# **Intel® Celeron™ Processor Specification Update**

Release Date: February 1999

Order Number: 243748-012

**Figure 20. Side View Space Requirements for the Boxed Processor**

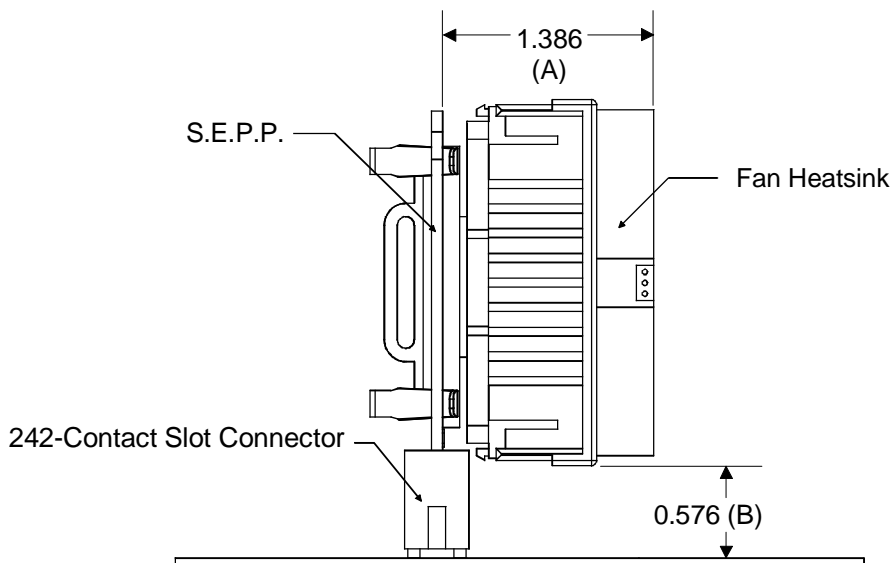
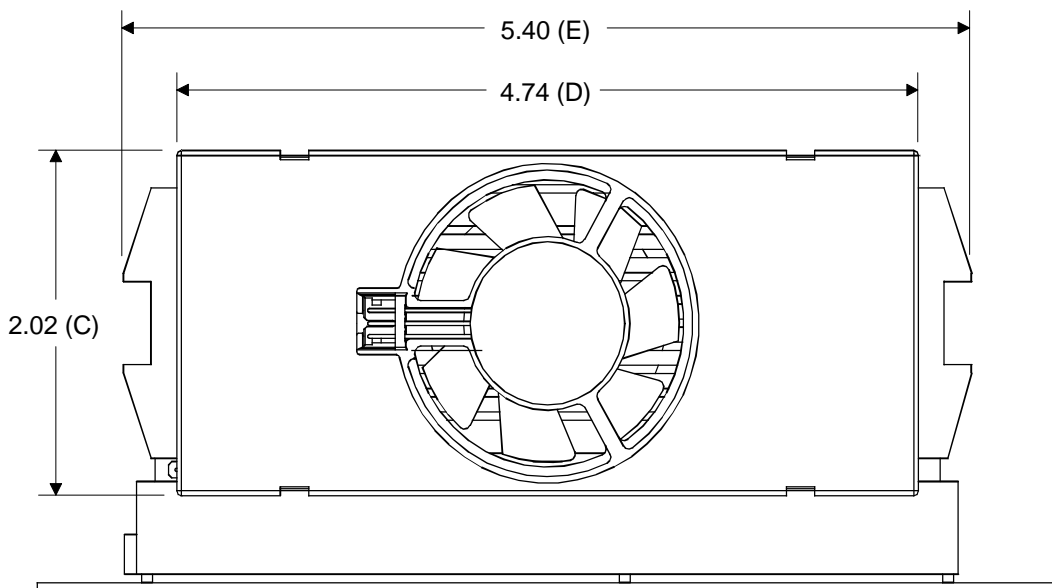
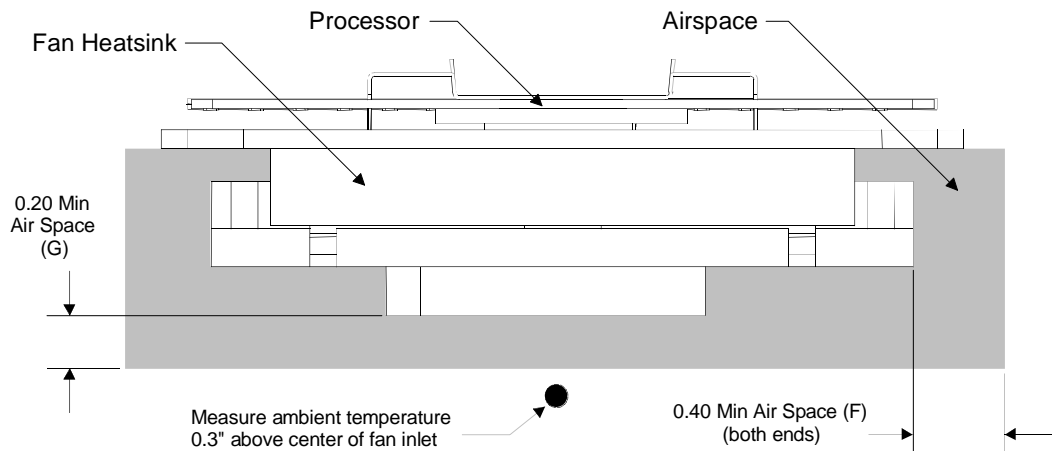
Figures 20, 21, and 22, and Table 34 of Section 6.2 of the *Intel® Celeron™ Processor* datasheet show incorrect fan heat sink dimensions for the boxed Intel Celeron processor. The correct figures and table are shown below.

The maximum depth of the fan heat sink to the processor substrate should be 1.386", not 1.291" max. The minimum height clearance above the baseboard should be 0.576", not 0.485". The fan shroud height should be 2.02" and 4.74", respectively, not 2.19" max. and 4.90" max. Figure 22 should show reference "G" for the minimum airflow keepout zone from the inlet of the fan heat sink, and reference "F" for the minimum airflow keepout zone from the ends of the fan heat sink.
